## Level 1 Floorplan

## Modifications

01 North Elevation  
Scale 1:200

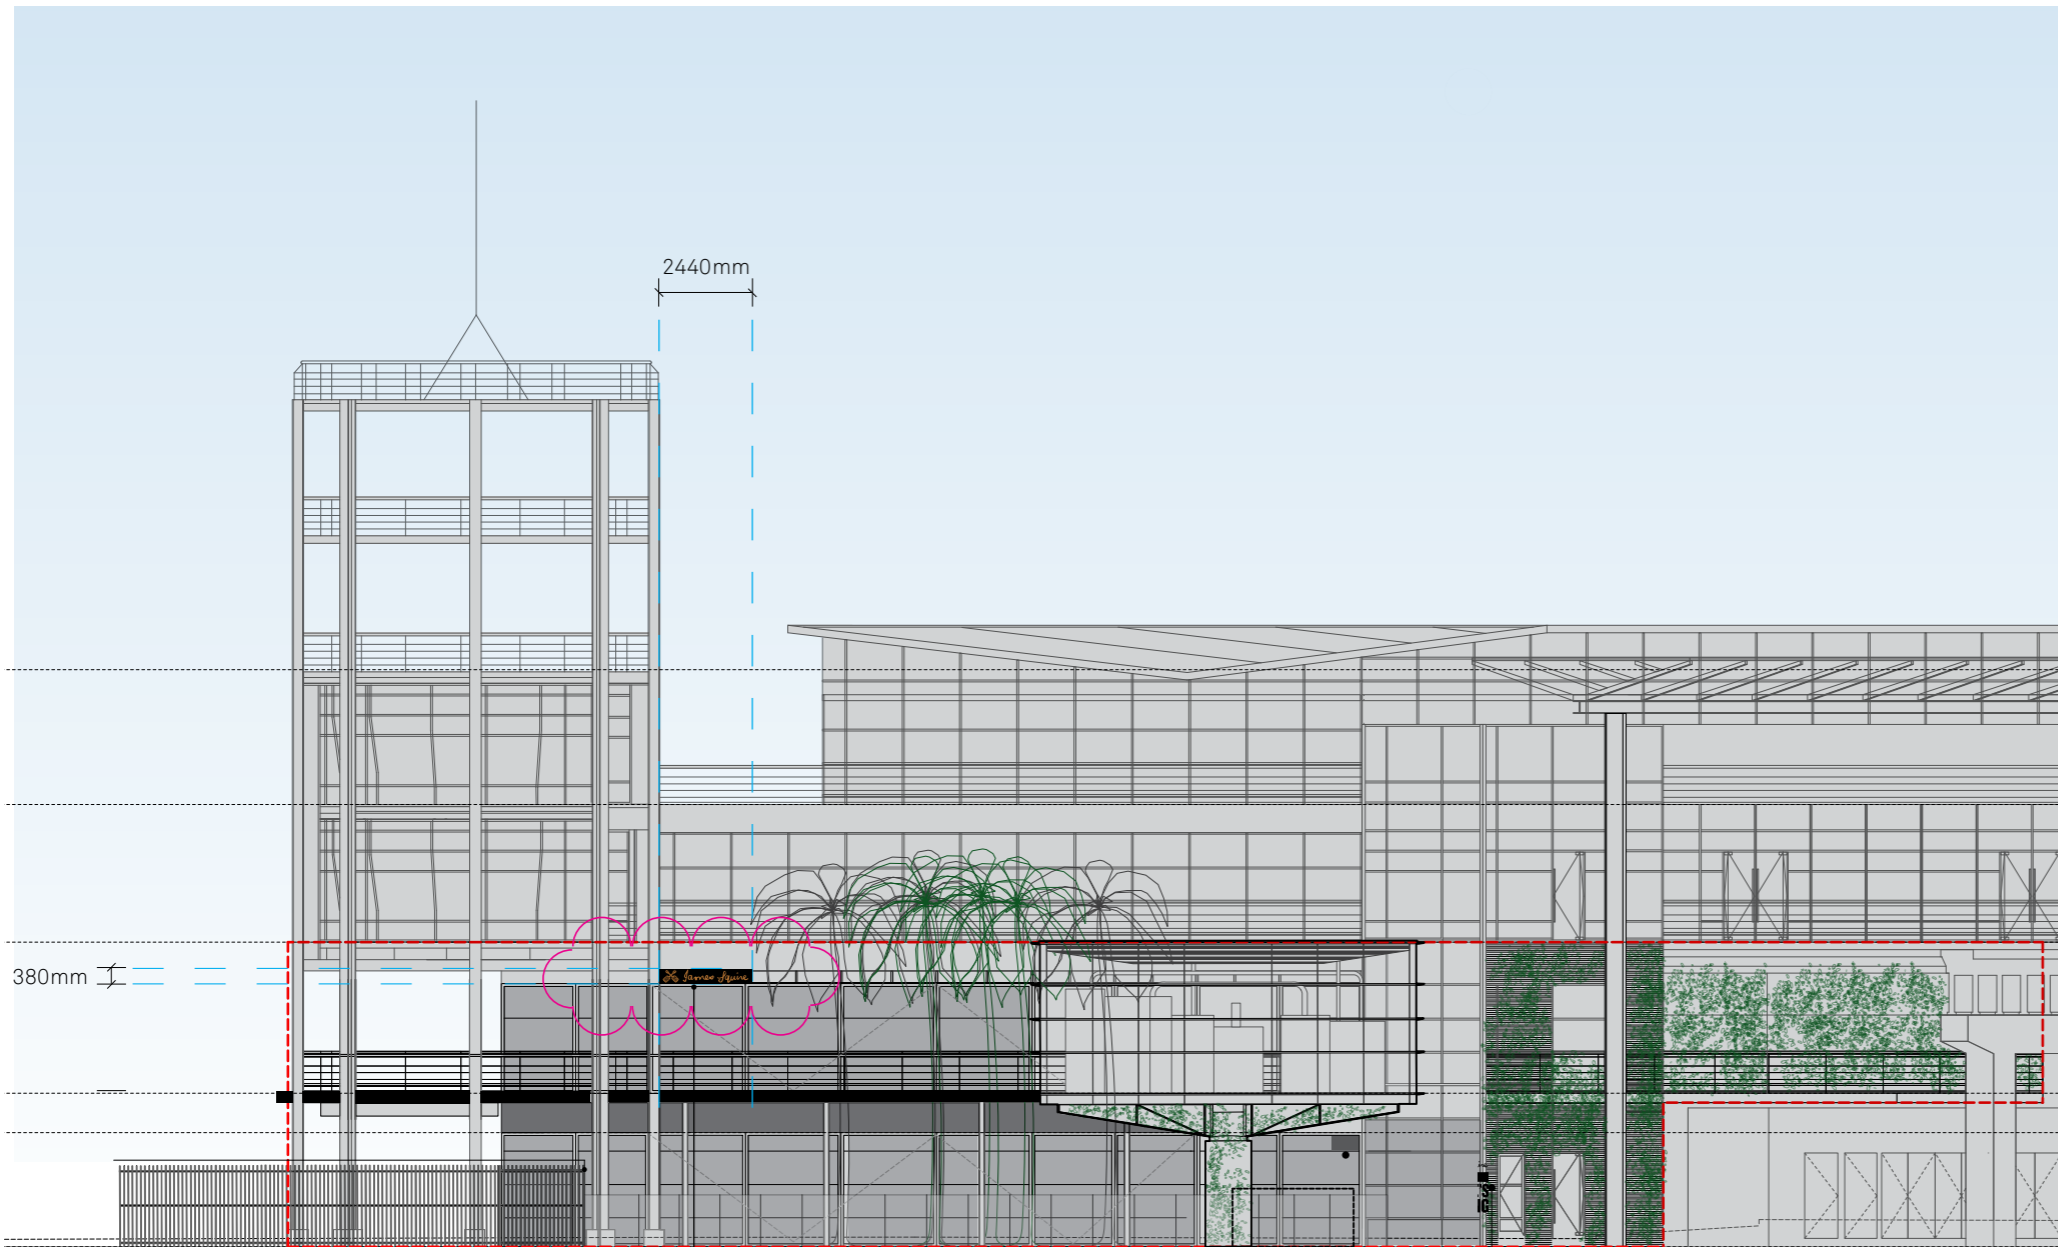
**James Squire Signature + Cross Shovels identification**  
**S3.2:** relocation from ground floor low level building spandrel to Level 2 awning beam. Size increases from 1285 x 220mm to 2440x380mm. Sign now halo lit.
